Re: Letter of Intent - The Moment Building Accent Lighting

Project Address 131 W Wilson Street, Madison, WI 53703

Re: The Moment
UDC comments regarding TYPES L3, L4
"Uncharted Waters"

DEEP GRAZER EXTRUSION + LED TAPELIGHT Fixture Type **L3**

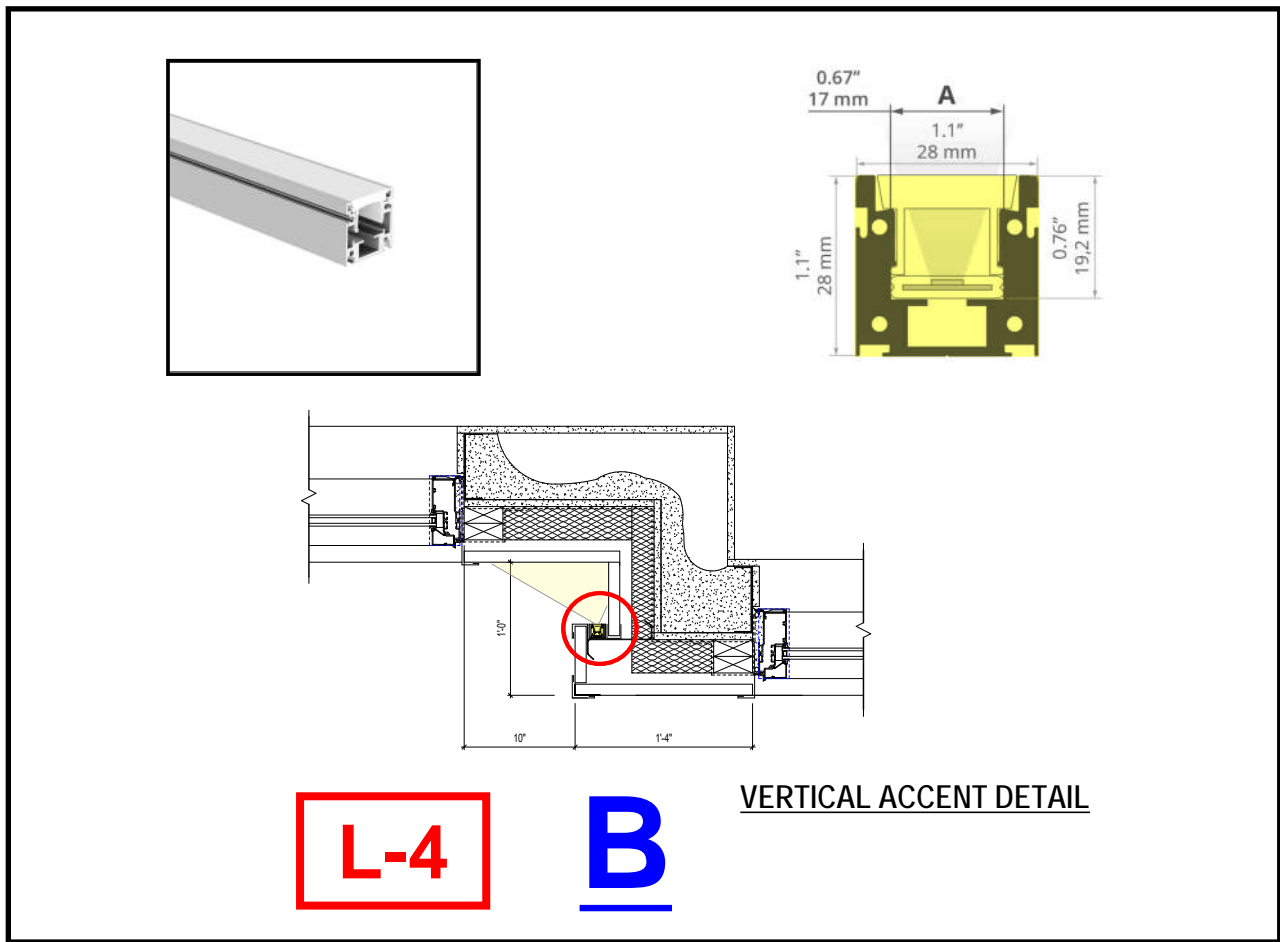
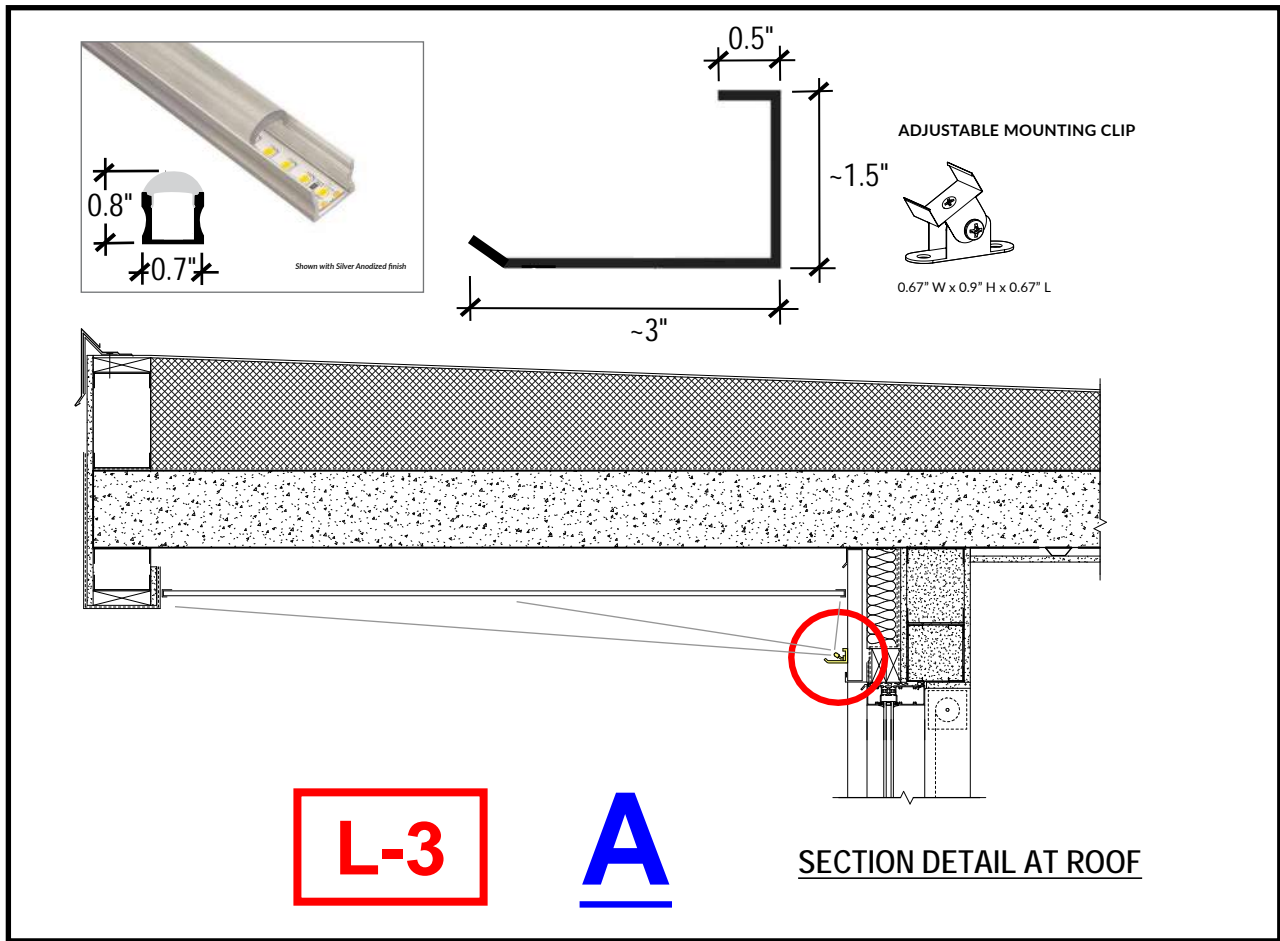
1. Fixture L3, lighting the top of the building finding that it is consistent with the Downtown Design Guidelines, granted that a cap (U shaped mounting versus J shaped mounting) is added to prevent direct view of the fixture.
2. Fixture L4 is modified to be compliant with cutoff requirements, and
3. Both fixtures shall return to the Commission for Final Approval.

In the UDC meeting on September 6, 2023, TYPE L3, L4 were reviewed by the group. Comments for TYPE L3, discussed partial approval, if the extrusion had an additional "lip" on the end of the extrusion which would provide additional concealment of the wet location LED extrusion and Adjustable Mounting Clip. Please see exhibit 'A' This extrusion from Eagle Mouldings will serve to provide the additional shield requested

Enclosed below is a letter from The Moment's lighting consultants, Steve Klein of Klein Lighting. The letter addresses the conditions of approval noting a U shaped mount (with a cap) has been added to Fixture L3, and Fixture L4 is modified to be compliant with cutoff requirements. Please read.

Fixture Type **L4**

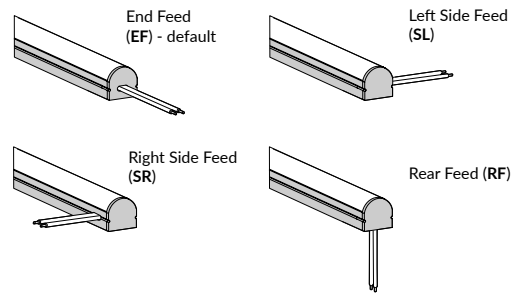
TYPE L4 was summarily rejected because illumination produced by the LED strips inside the extrusion, even though the extrusion had a white diffuser lens, which, when mounted on the building produced direct brightness. Individuals in the group differed in opinion as to whether this way of producing the intended effect lacked subtlety. Although the code does not contemplate a continuous line of light, the design was potentially approvable because it is not illegal. All the group seemed to agree that if the effect could be made to be indirect, such as back lighting letters in signage, or creating a "halo effect" that would be approvable.

In response to this suggestion, we propose a different LED extrusion and mounting method. Please see exhibit 'B' The key to success is the mounting bracket which will allow a 90Degree rotation of the New Extrusion from KLUS. This means that the strip is now intended to point into a 'U' shaped architectural metal wall panel pocket and produce an indirect effect, which all members of the group seemed to think was OK. The lumens required to produce an indirect effect will necessarily be more than originally specified because of the 40% absorption of the lens and the fact that it is shining back at the building and reflecting off the interior of the pocket.
